ADDENDUM #2

REQUEST FOR QUOTATIONS (RFQ) No. : 1220-040-2022-051

TITLE: RCMP Boiler Replacement

ADDENDUM ISSUE DATE: May 20th, 2022

Attachment 2

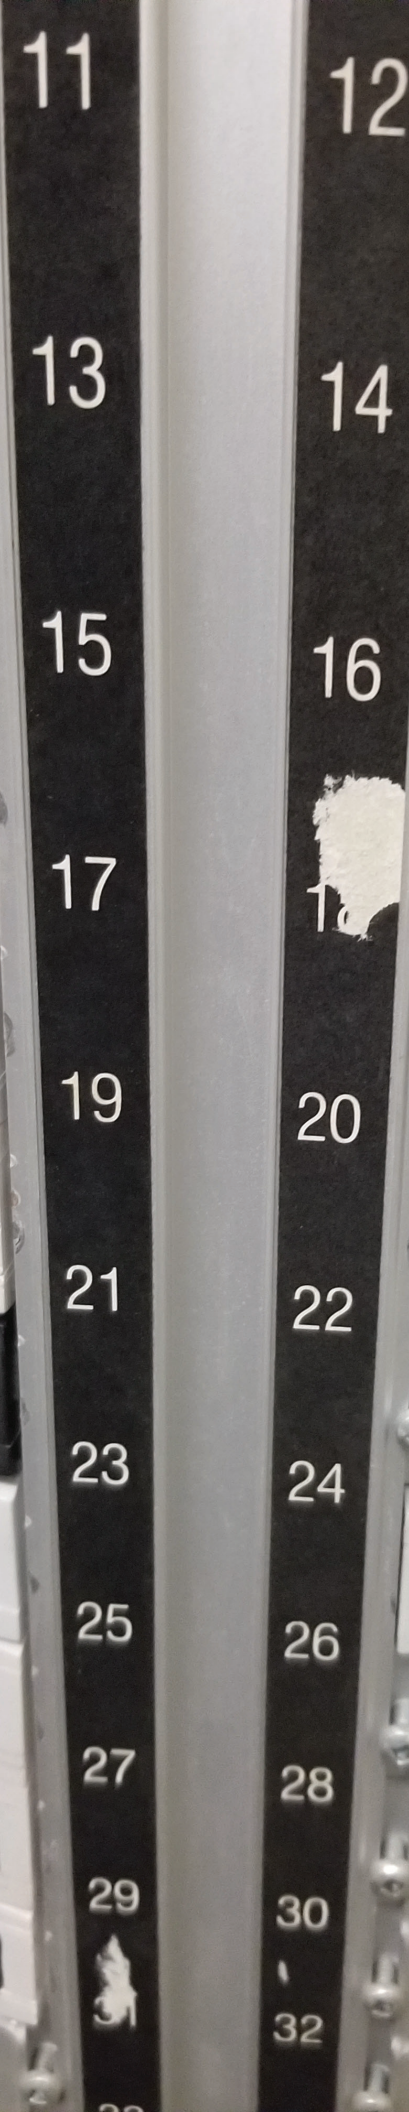
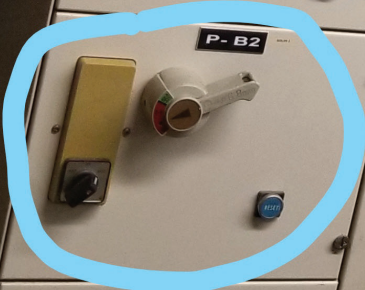
Q.1. We would like to request the following information to properly quote this project:

PICTURES/SCREENSHOTS:

- Existing Boilers:
 - Front Picture
 - Side Picture (either one)
 - Back Picture
 - Piping associated to existing neutralization tanks
- New Electric DHW Tank:
 - 2 picture from different angles of the space where the DHW tank will be located

- Piping to connect to should be shown in the pictures
- Flue Venting and :
 - Raiser from boiler to ceiling level
 - Horizontal section (a couple of pictures)
 - Flue venting insertion to shaft/wall penetration
 - Combustion air ductwork shaft/wall penetration
- Shaft:
 - Picture of shaft...
- Building Elevation:
 - Provide a screenshot of a building elevation drawings (omit confidential information) where building heights can be observed
 - Boiler Room height
 - Shaft height
 - Roof top height
- Electrical:
 - Pumps and boiler panel

A.1. Reference Attachment 2 for available photos.
